Subject: Transmittal of Revision 1 to Service Bulletin No. V2500-ENG-72-0079

V2500-ENG-72-0079

ENGINE - HP COMPRESSOR - INTRODUCE A STRENGTHENED NO.4
BEARING BUFFER AIR TUBE BRACKET ASSEMBLY

Location of No.4 Bearing Buffer Air Tubes and Clipping Positions
CP5229, CP5230, CP5231, CP5232, CP5233 and CP5234
Figure 1, Sheet 1 of 2

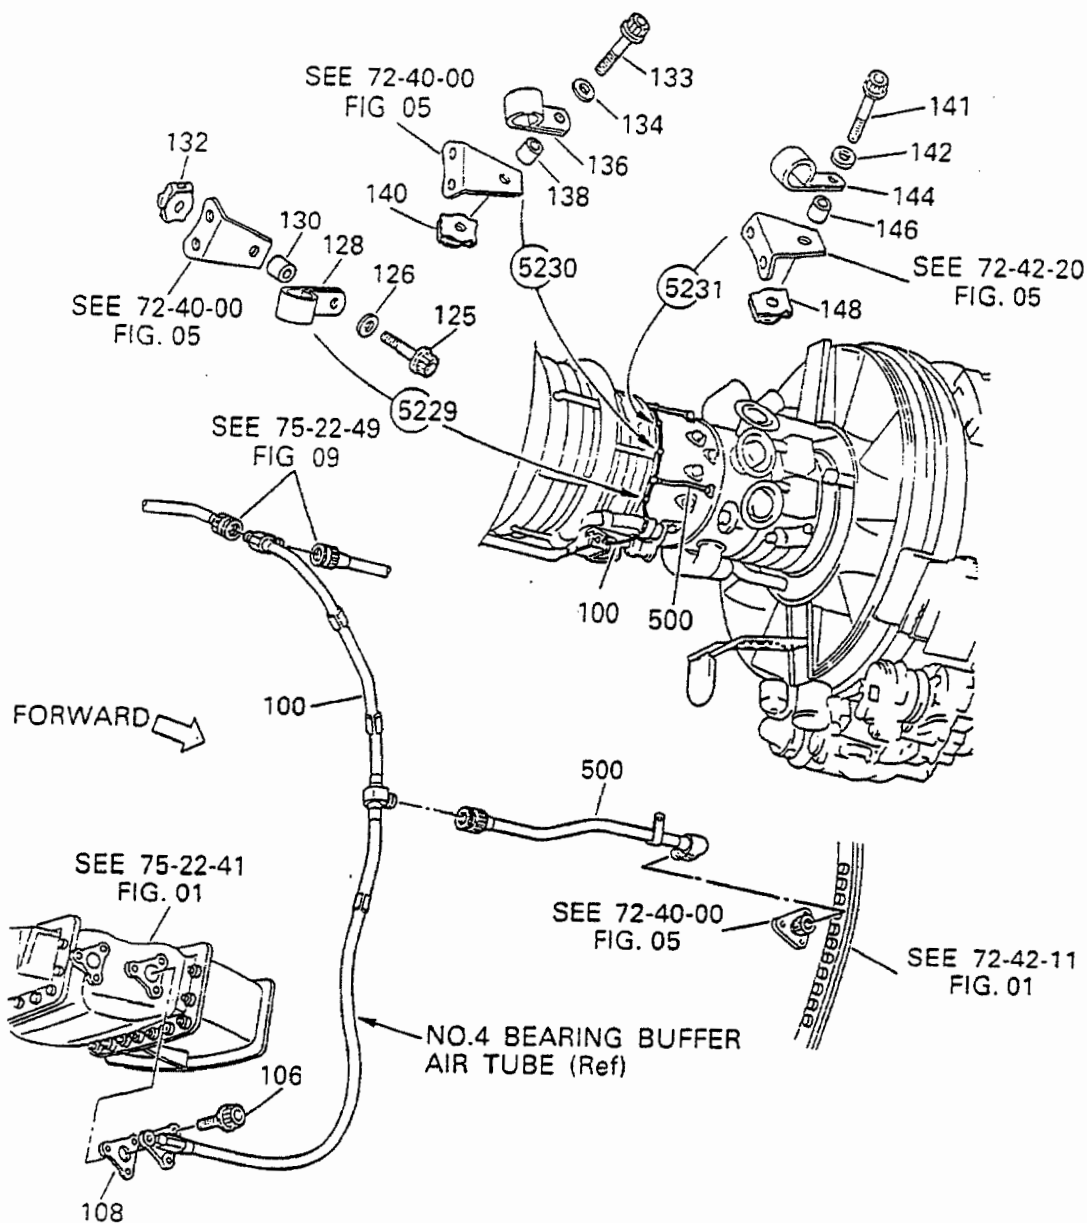
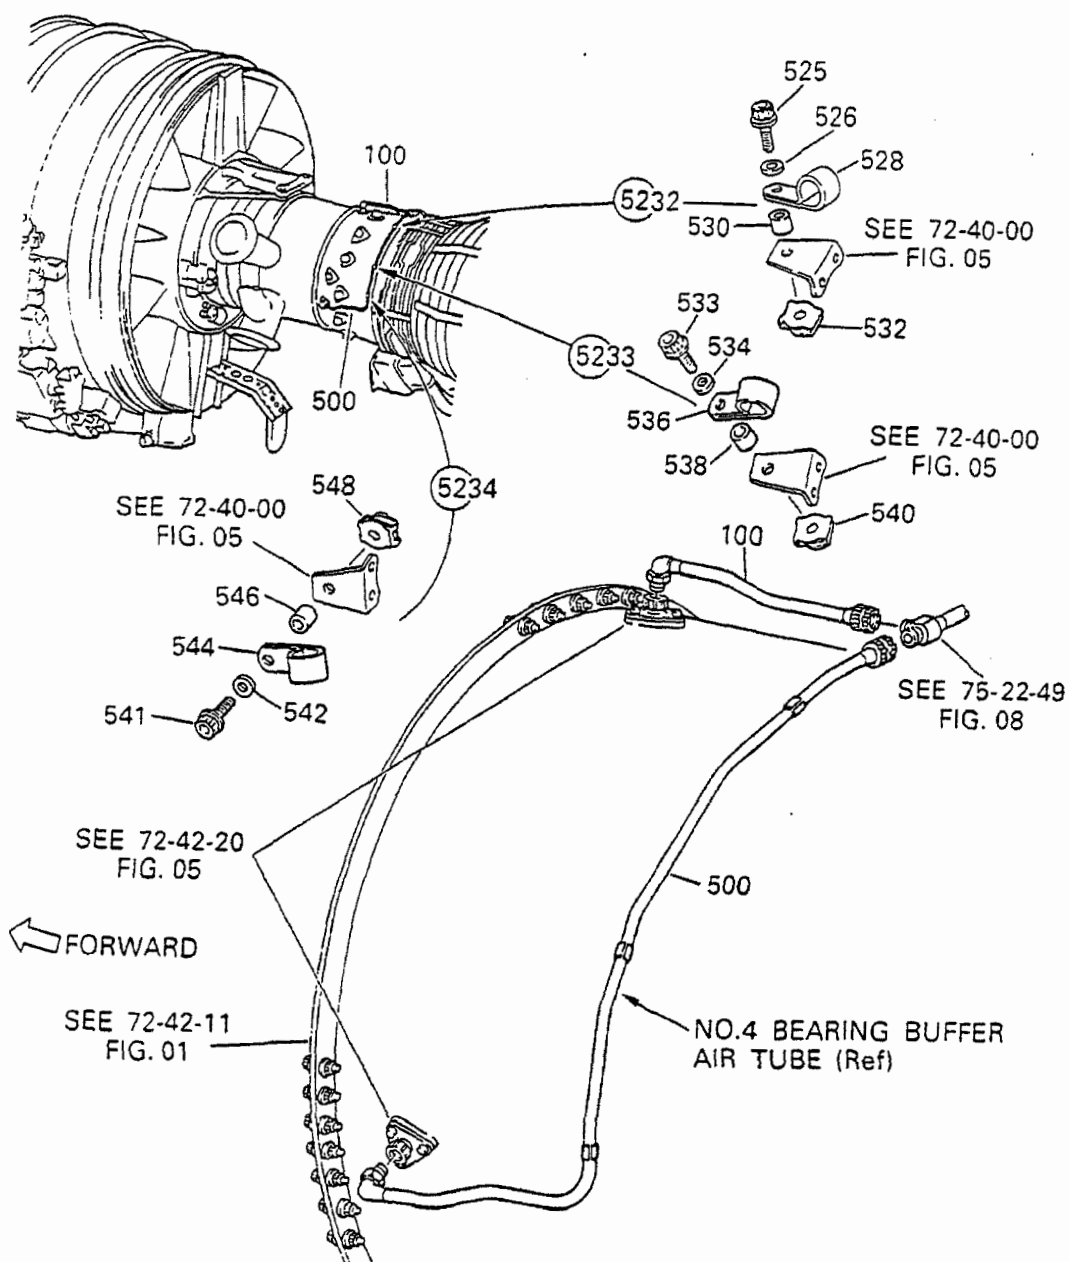
- (2) Install the No.4 Bearing Buffer Air Tubes to the HPC System Module as follows (Refer to Figures 1, 2 and I.K.(3)):
 - (a) Connect the No.4 Bearing Buffer Air Tubes and torque the tube Nuts by the approved procedures in the Engine Manual, 72-00-40, Installation, TASK 72-00-40-420-007.

Clipping Detail at CP5229, CP5230, CP5231, CP5232, CP5233 and CP5234 -
Before and After Alteration
Figure 2

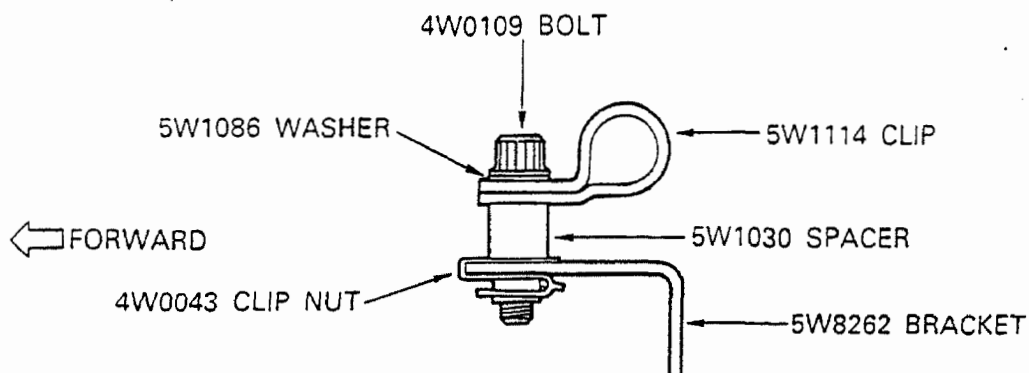
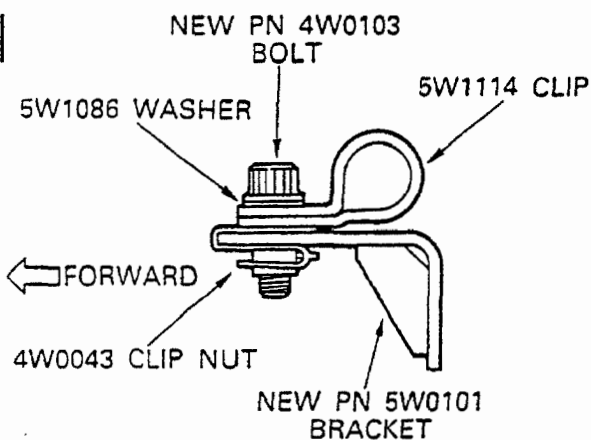
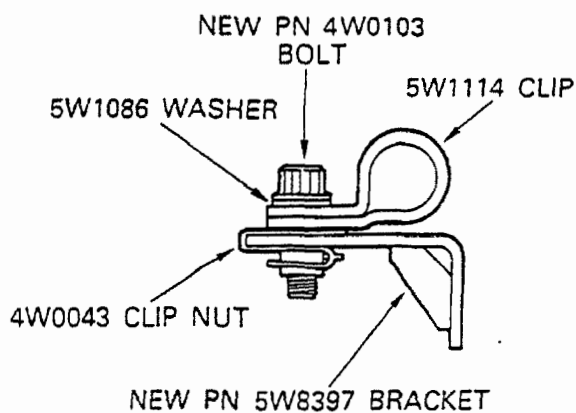
- (a) The existing six 5W8262, Brackets at the Flange FM are replaced with the three new 5W0101, Brackets with gussets and the three new 5W8397, Brackets with gussets to increase the strength of clipping Brackets (See Figure 3).
- (b) At each of clipping positions CP5229, CP5230, CP5231, CP5232, CP5233 and CP5234, the existing 5W1030, Spacer is deleted and also clipping Bolt is changed from 4W0109 to 4W0103 to decrease the length of Bolt (See Figure 2).

- (b) At each of Clipping Positions CP5229, CP5230, CP5231, CP5232, CP5233 and CP5234, install the new 4W0103, Bolt, 5W1086, Washer, 5W1114, Clip 4W0043, Clip Nut to the Tube and the Bracket. Torque each Bolt to 36 to 45 lbfin (4,00 to 5,00 Nm).

Clipping Brackets at Flange FM — Before and After Alteration
Figure 3 Sheet 1 of 2

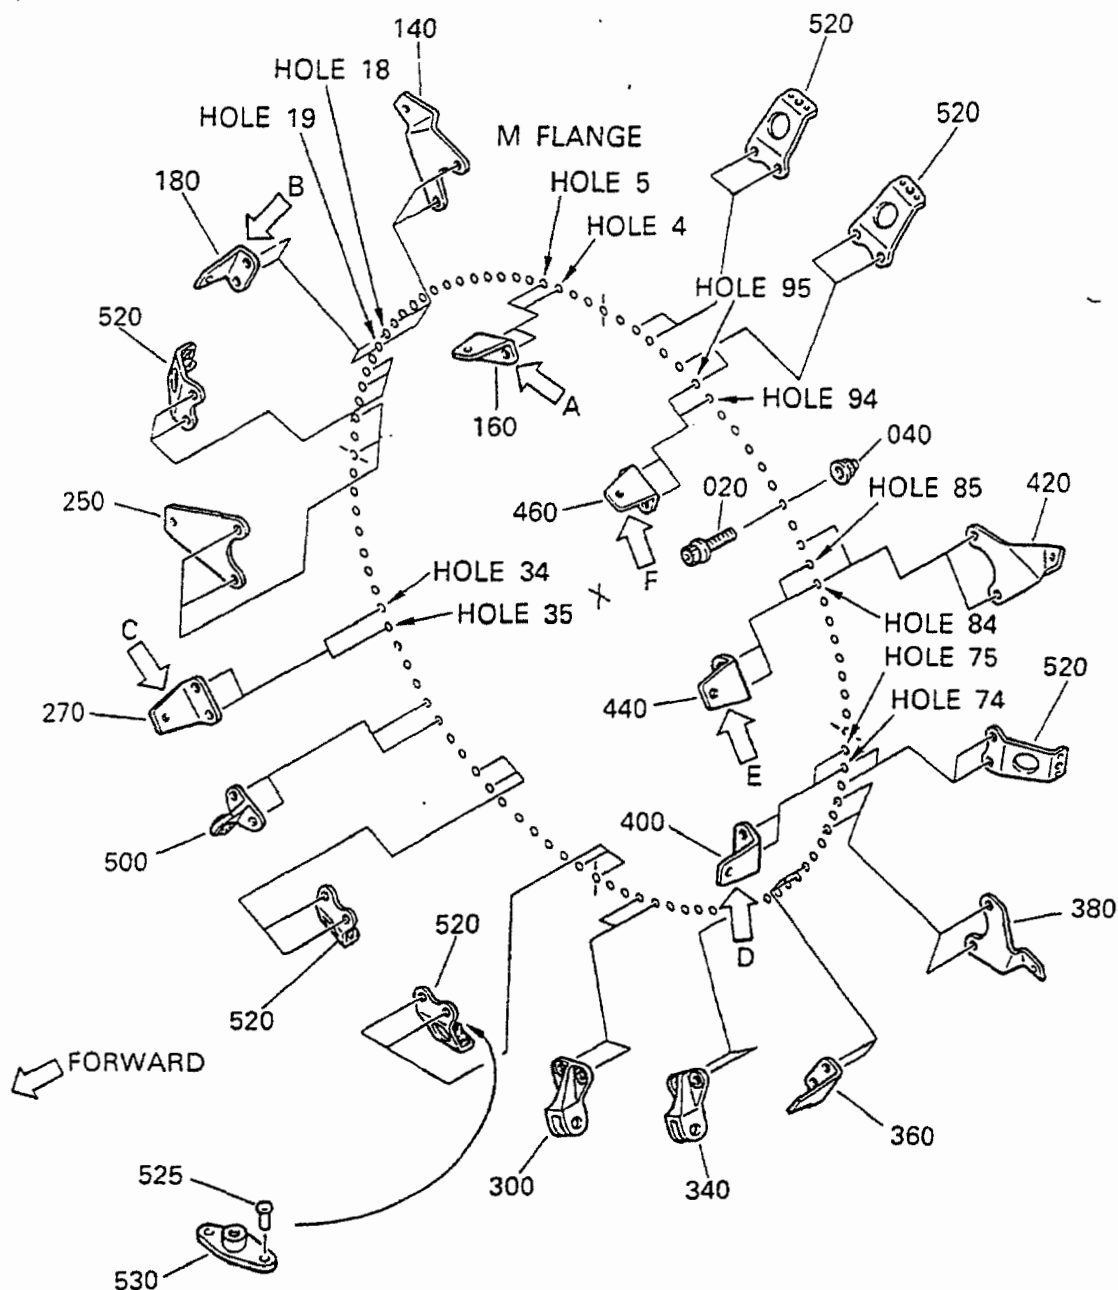
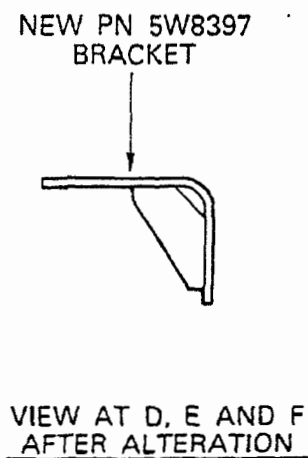
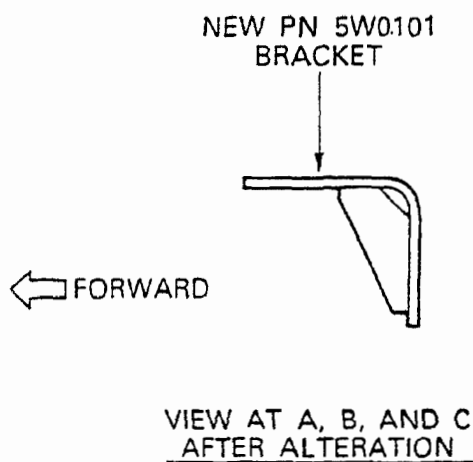
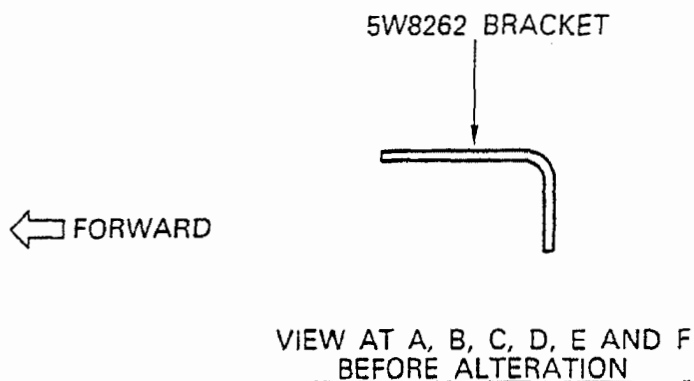
- (1) Install the clipping Brackets to the Flange FM as follows (Refer to Figure 3 and I.K.(3)):
 - (a) At Flange hole No.4 and 5, attach the new 5W0101, Bracket with the two 4W0471, Bolts and 4W0003, Nuts.

- (b) At Flange hole No.18 and 19, attach the new 5W0101, Bracket with the two 4W0471, Bolts and 4W0003, Nuts.
 - (c) At Flange hole No.34 and 35, attach the new 5W0101, Bracket with the two 4W0471, Bolts and 4W0003, Nuts.

- (d) At Flange hole No.74 and 75, attach the new 5W8397, Bracket with the two 4W0471, Bolts and 4W0003, Nuts.
 - (e) At Flange hole No.84 and 85, attach the new 5W8397, Bracket with the two 4W0471, Bolts and 4W0003, Nuts.

- (f) At Flange hole No.94 and 95, attach the new 5W8397, Bracket with the two 4W0471, Bolts and 4W0003, Nuts.
 - (g) At Flange hole No.4, 5, 18, 19, 34, 35, 74, 75, 84, 85, 94 and 95, torque each Bolt to 180 to 220 lbfin (20,00 to 25,00 Nm).
